SUBDIVISION REVIEW SHEET**CASE NO.:** C8-2023-0067.0A**COMMISSION DATE:** August 15, 2023**SUBDIVISION NAME:** Poss-Laitner Subdivision**ADDRESS:** 10500 E Parmer Lane**APPLICANT:** Jeff Poss (Poss Holdings, LLC)**AGENT:** Tyler Boykin (Mahoney Engineering, LLC)**ZONING:** PUD**NEIGHBORHOOD PLAN:** N/A**AREA:** 2.2 Acres**LOTS:** 1**COUNTY:** Travis**DISTRICT:** 1**WATERSHED:** Gilliland Creek**JURISDICTION:** Full Purpose**SIDEWALKS:** Sidewalks will be constructed along the subdivision side of E Parmer Lane.**VARIANCE:** N/A**DEPARTMENT COMMENTS:**

CITY OF AUSTIN –DEVELOPMENT SERVICES DEPARTMENT
SUBDIVISION APPLICATION – MASTER COMMENT REPORT

CASE NUMBER: C8-2023-0067.0A
UPDATE: U1
CASE MANAGER: Nicholas Coussoulis

PROJECT NAME: Poss-Laitner Subdivision
LOCATION: 10500 E PARMER LN

Exhibit B: Proposed plat

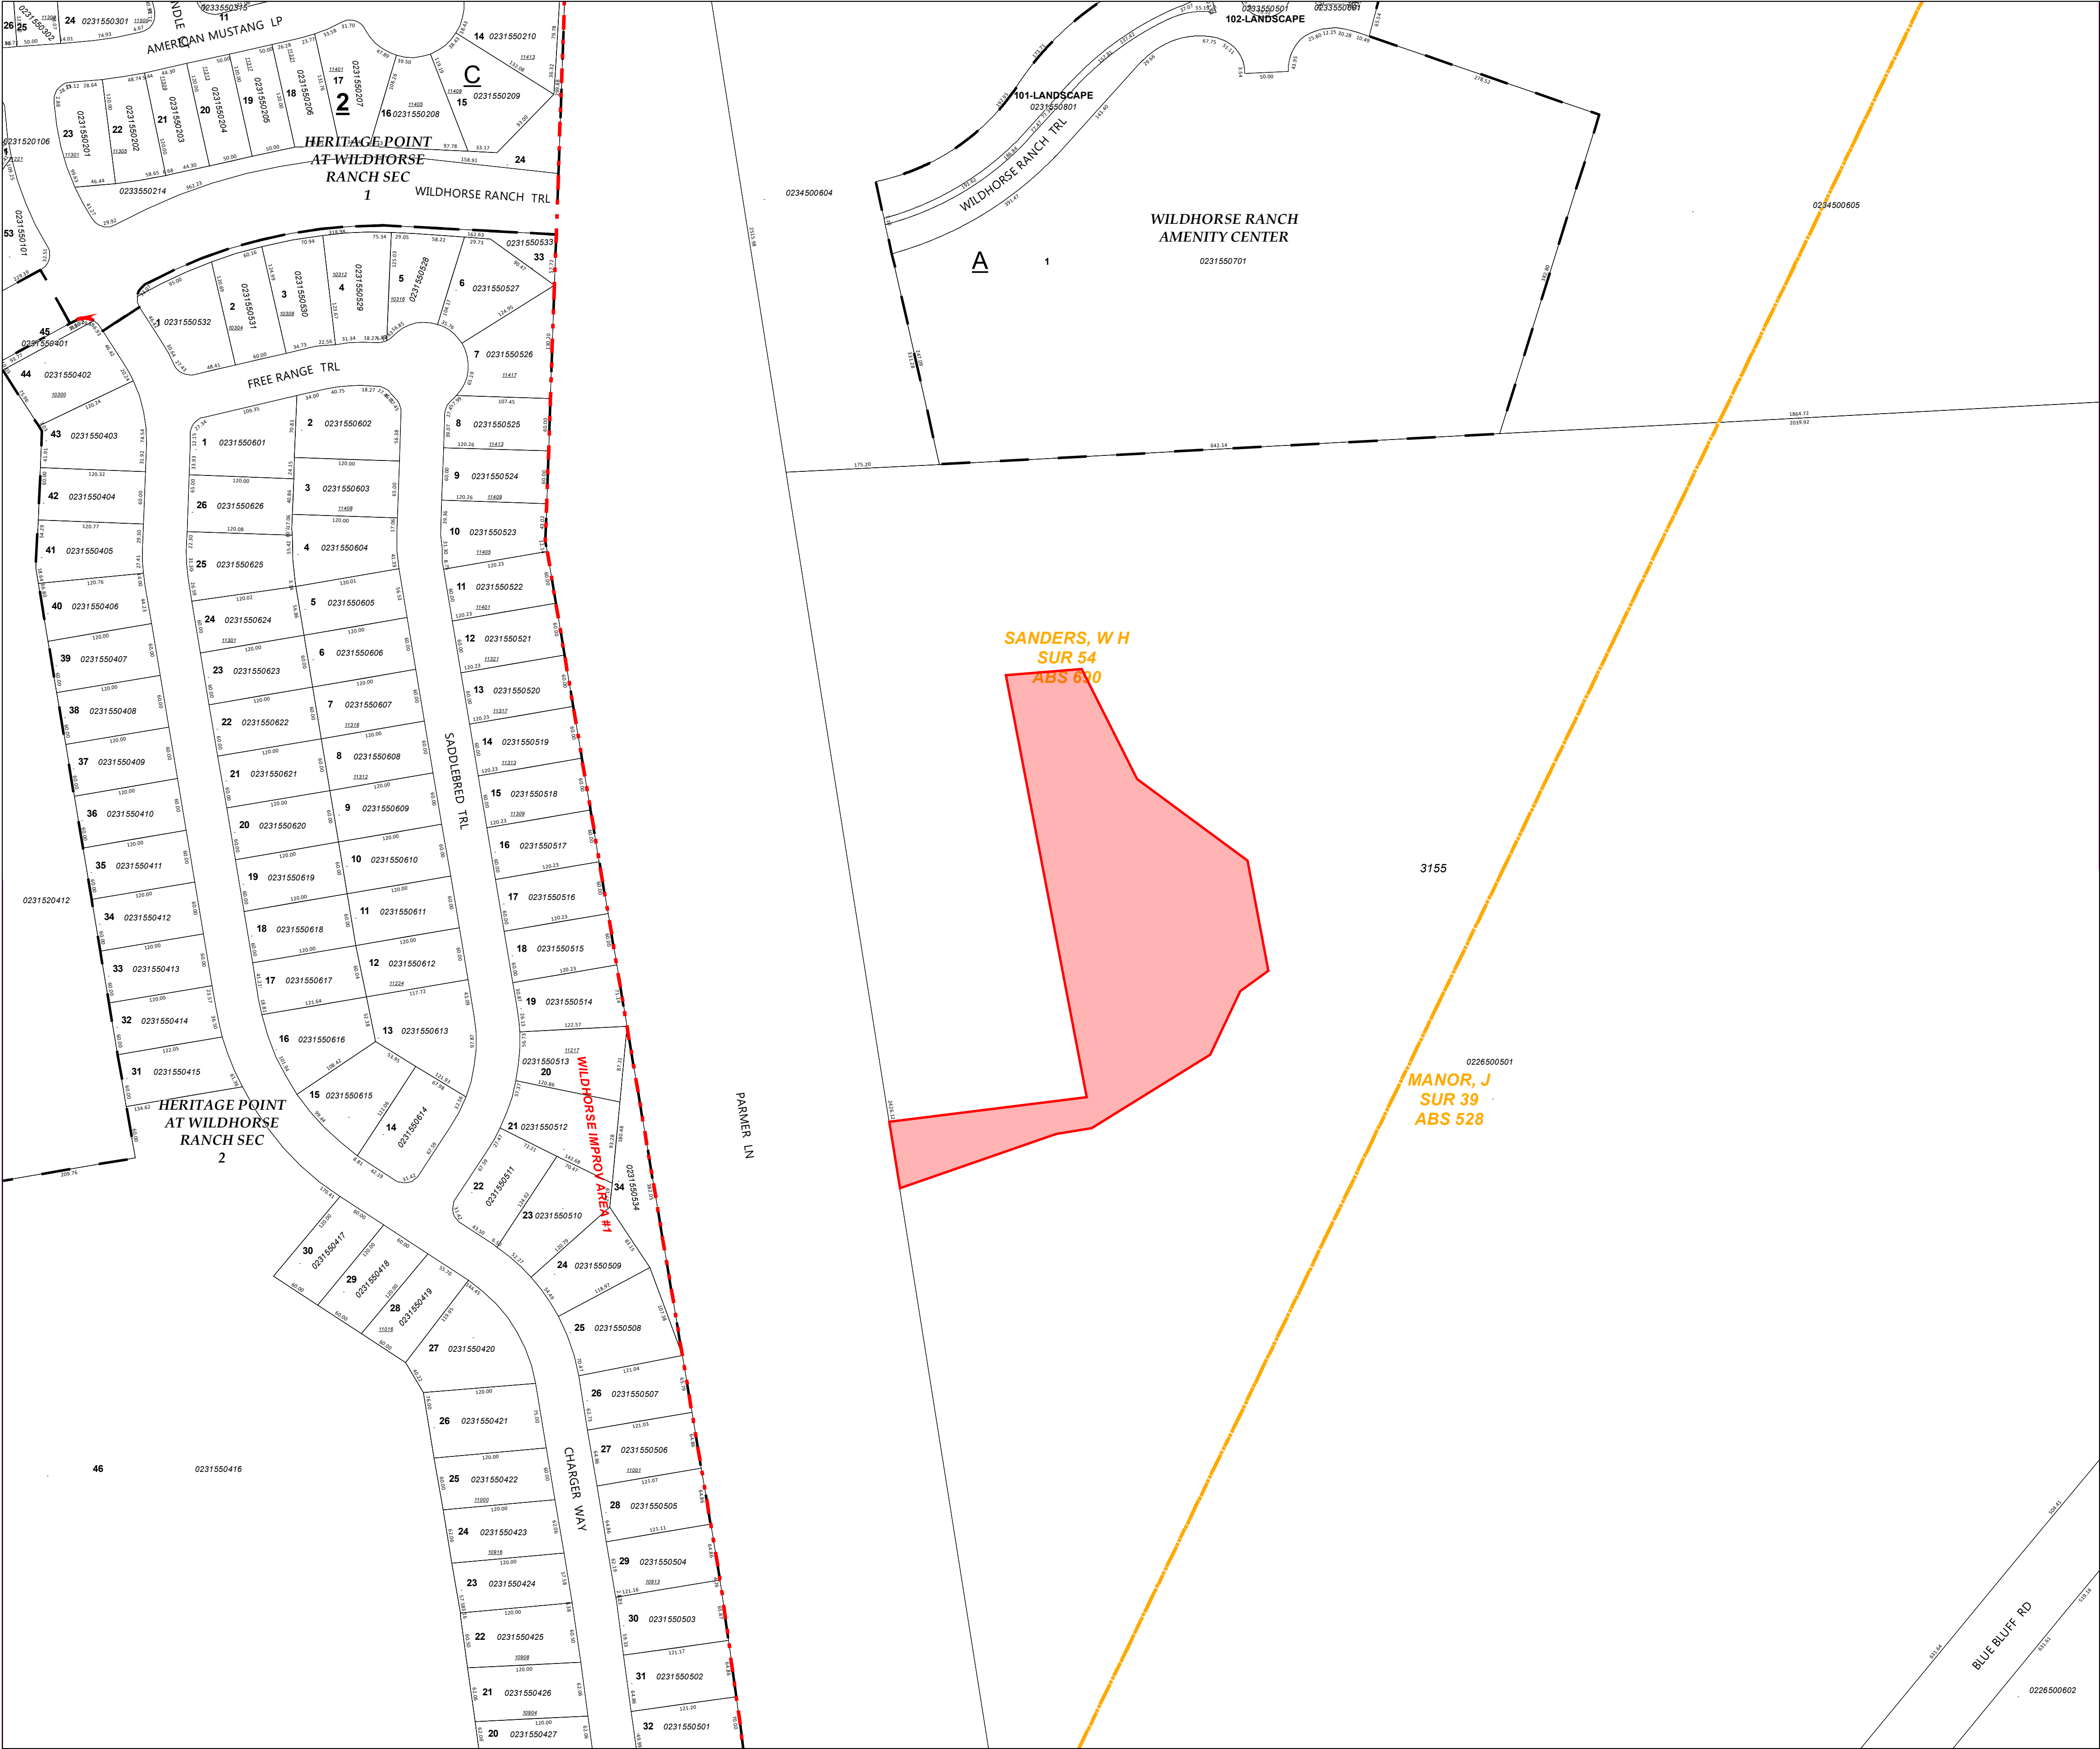
ATD 4. Sidewalks are required on the subdivision side of E PARMER LN. Identify the location of the sidewalks by a dotted line on the final plat and include the sidewalk symbol within the legend.

SR 2. Add Case # **C8-2023-0067.0A** in the bottom right-hand corner of each sheet. 25-1-83

SR 3. Include the square footage of the Lot 1 underneath the acreage. 25-1-83

U1: Comment cleared.

- U1: Comment Cleared.

- U1: Comment Cleared.

W. S.E.R. Name: Poss-Laitner Tract

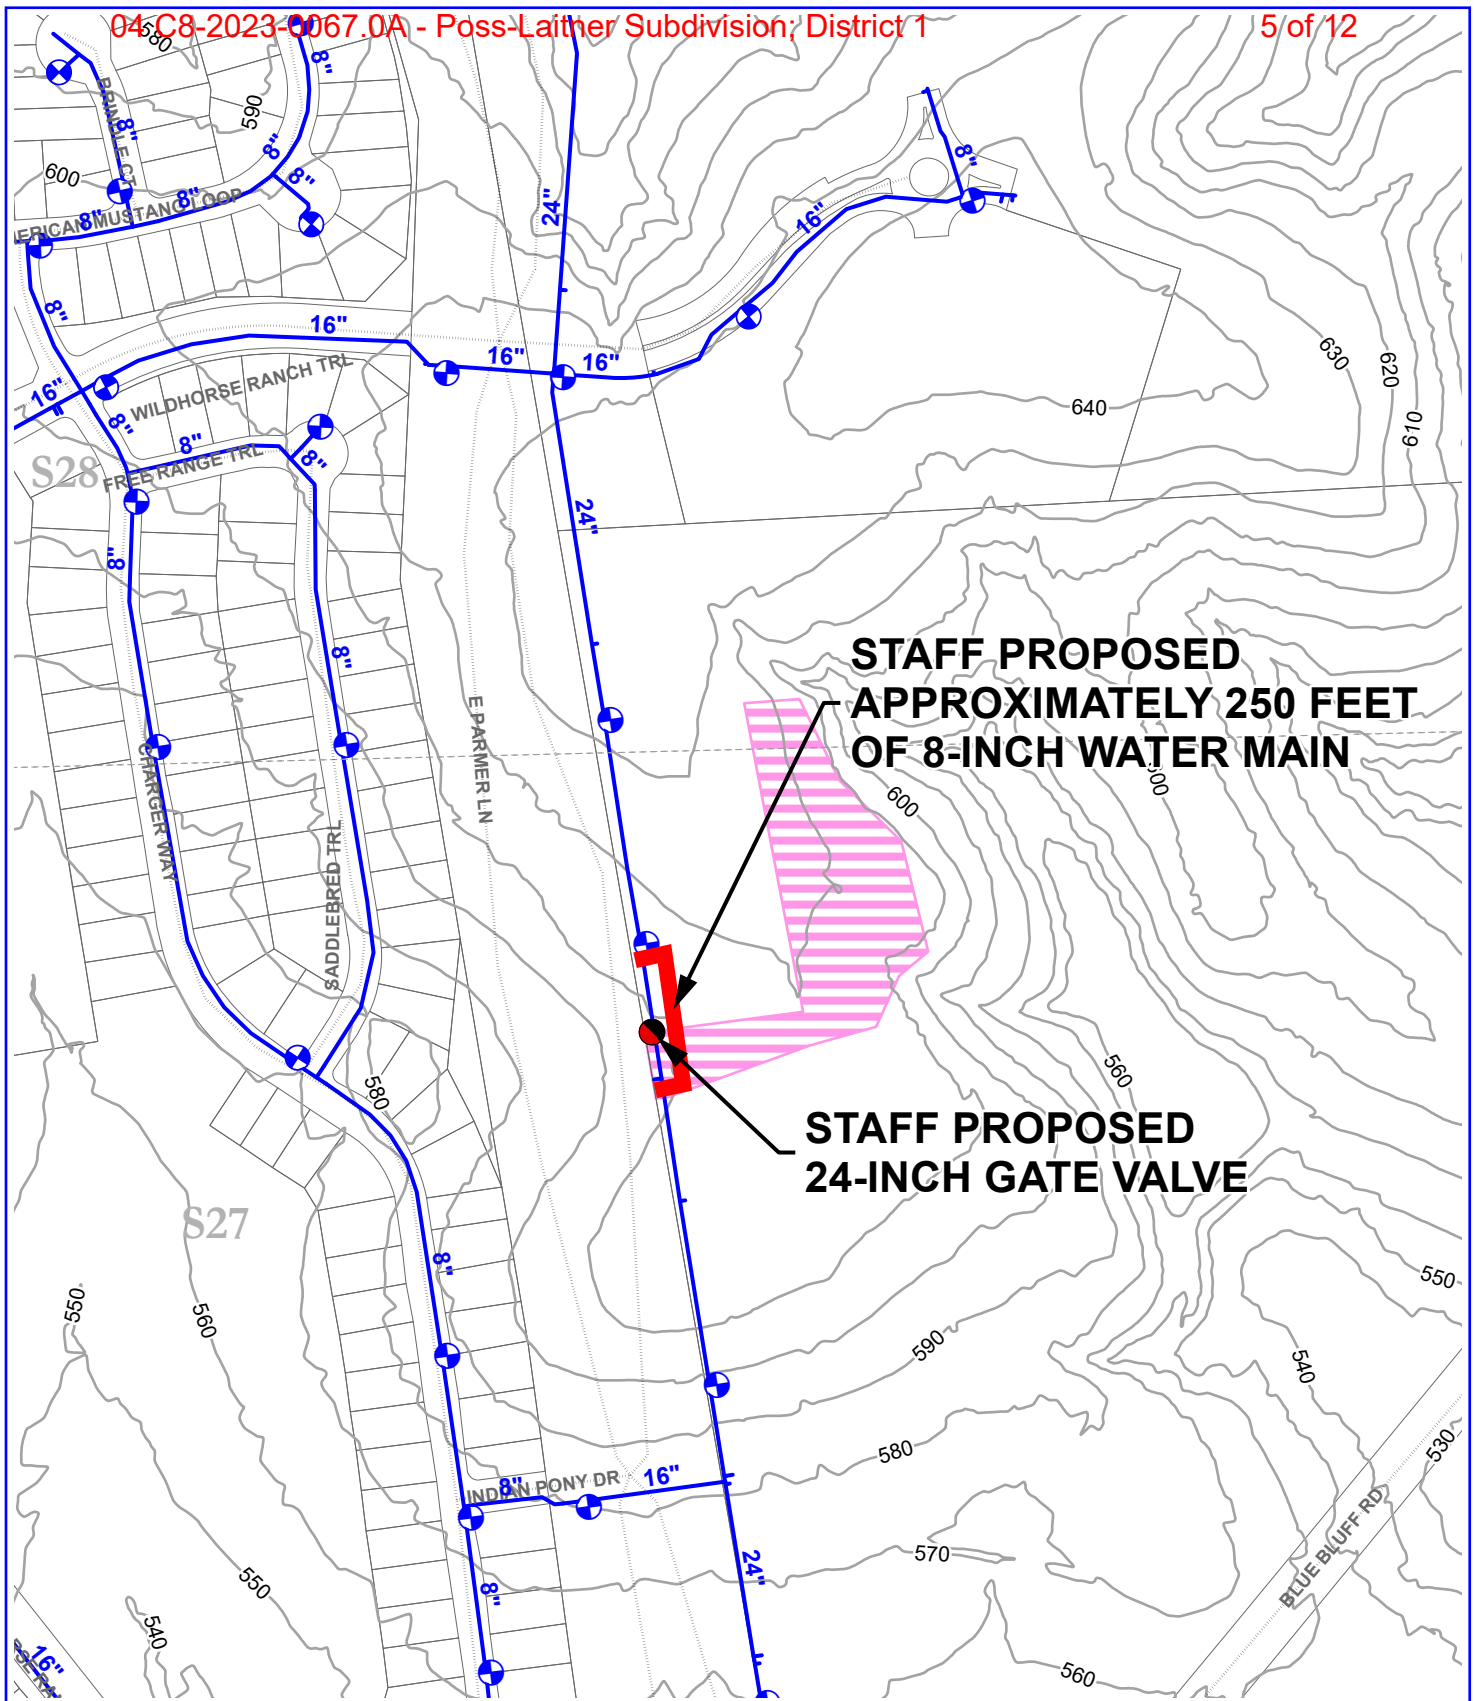
Description of Improvements:
Applicant shall construct approximately 250 feet of 8-inch water main from the existing 24-inch water transmission main (Project No. 2015-0914) in E Parmer Ln located north of the subject tract and extend south along E Parmer Ln to the subject tract and make a second connection to the existing 24-inch water transmission main (Project No. 2015-0914), as approximately shown on the attached map. Applicant shall also construct a 24-inch gate valve between the two connections to the existing 24-inch water transmission main.

W.W. S.E.R. Name: Poss-Laitner Tract

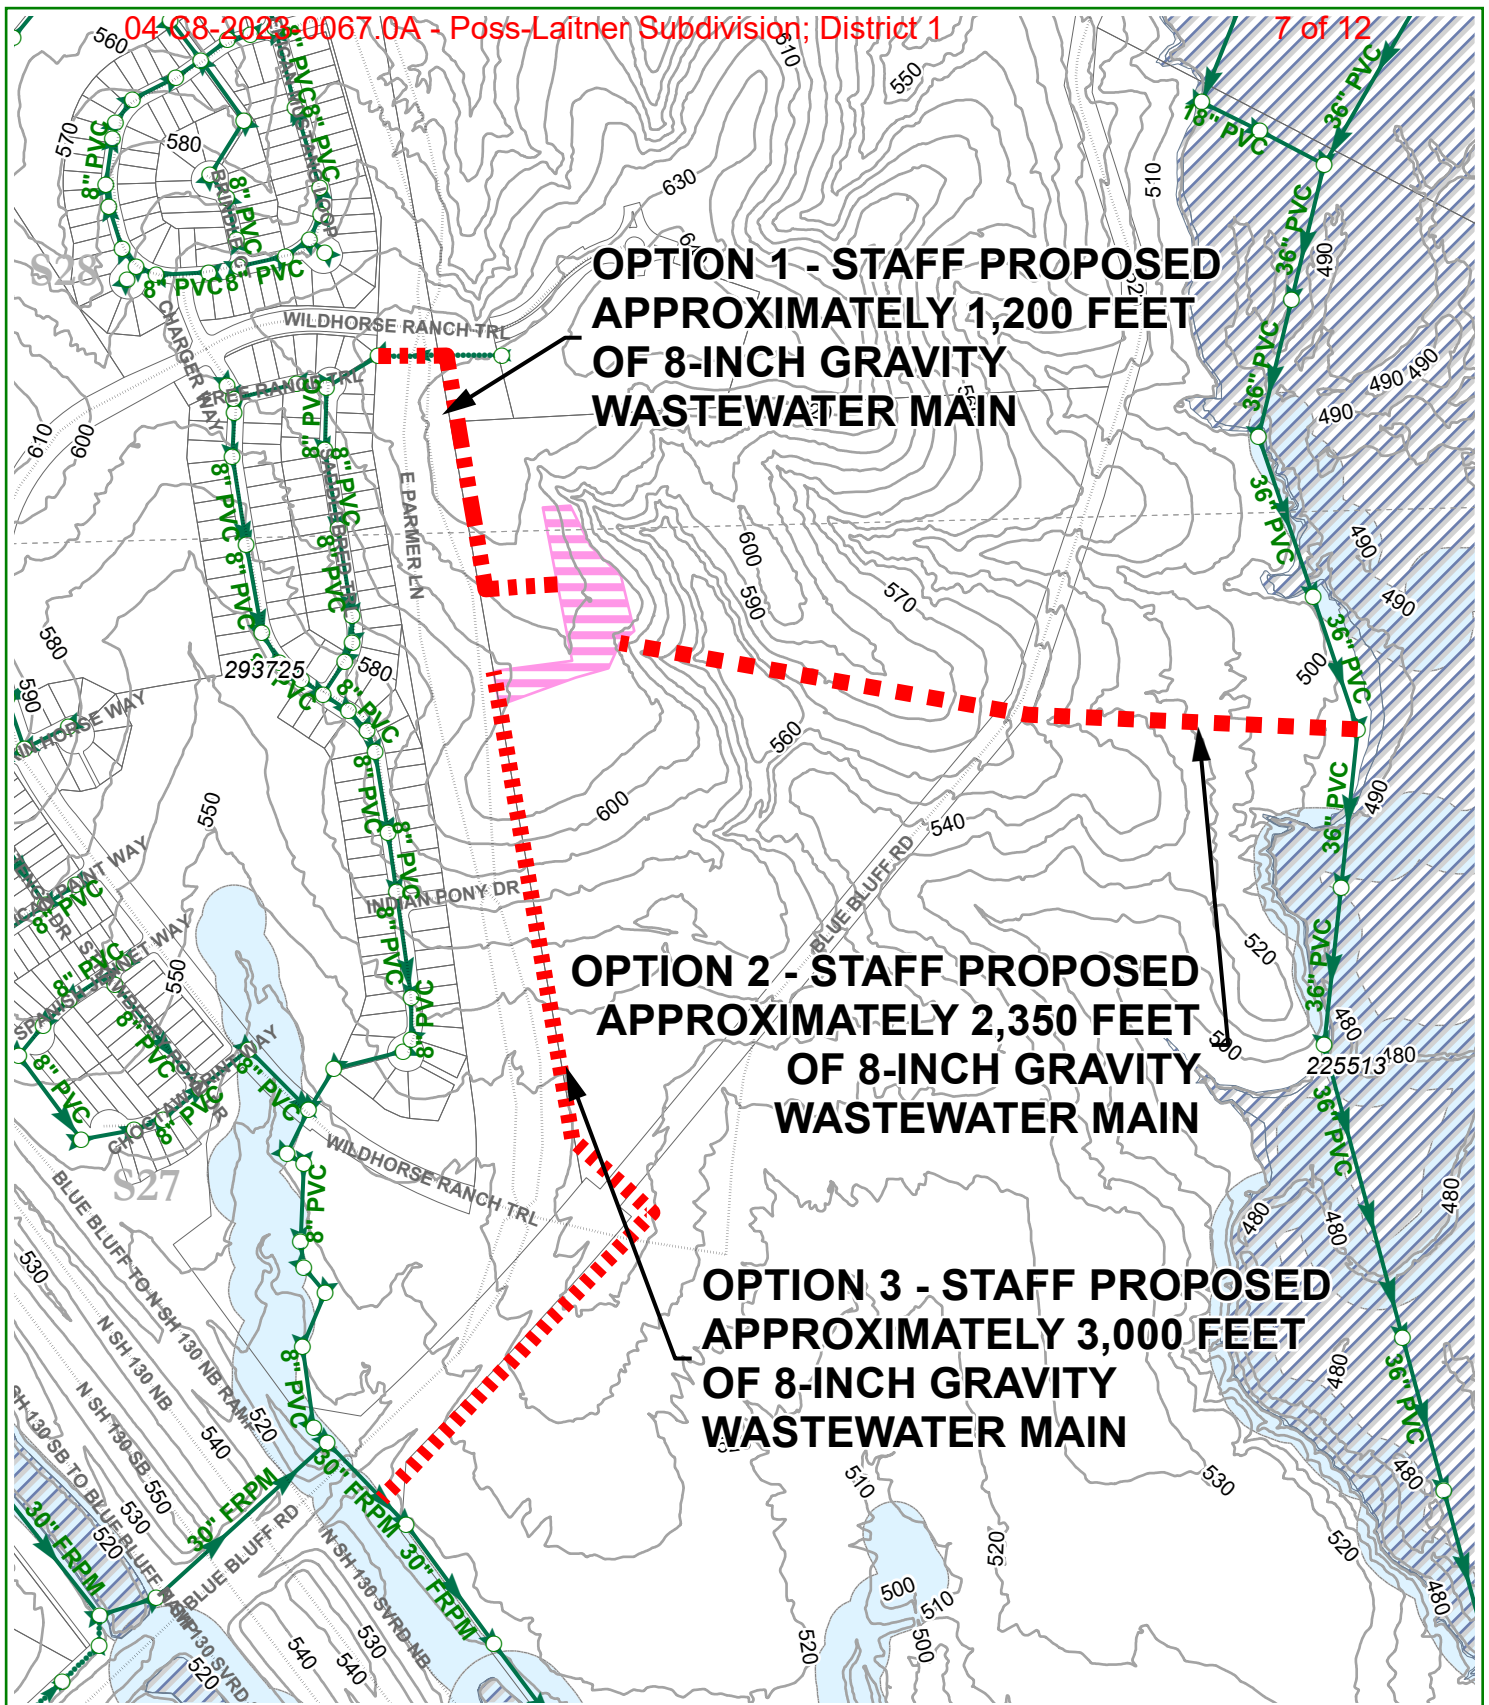
Description of Improvements:
Wastewater Service Option 1
Applicant shall construct approximately 1,200 feet of 8-inch gravity wastewater main from the existing 8-inch gravity wastewater main (Project No. 2019-1091; MH ID# 293725) located northwest of the subject tract and extend east across E Parmer Ln, south along E Parmer Ln, and then east to the subject tract, as approximately shown on the attached map. A portion of the proposed wastewater main is also proposed by Wildhorse Ranch Amenity Center (SER-4323; SP-2018-0610C). If these wastewater improvements are required by the Applicant's project before they are completed by the Wildhorse Ranch Amenity Center project, the design and construction of the wastewater improvements are the responsibility of the Applicant.

Wastewater Service Option 2
Applicant shall construct approximately 2,350 feet of 8-inch gravity wastewater main from the existing 36-inch wastewater interceptor (Project No. 2004-0002; MH ID# 225513) located east of the subject tract and extend west to the subject tract, as approximately shown on the attached map. A portion of the proposed wastewater main is also proposed by Saddle Ridge at Wildhorse Ranch Section 1 (SER-4716; C8-2020-0033.1B). If these wastewater improvements are required by the Applicant's project before they are completed by the Saddle Ridge at Wildhorse Ranch Section 1 project, the design and construction of the wastewater improvements are the responsibility of the Applicant.

Wastewater Service Option 3
Applicant shall construct approximately 3,000 feet of 8-inch gravity wastewater main from the existing 30-inch wastewater interceptor (Project No. 2006-0527) located along N SH 130 NB and extend northeast and north along E Parmer Ln to the subject tract, as approximately shown on the attached map.
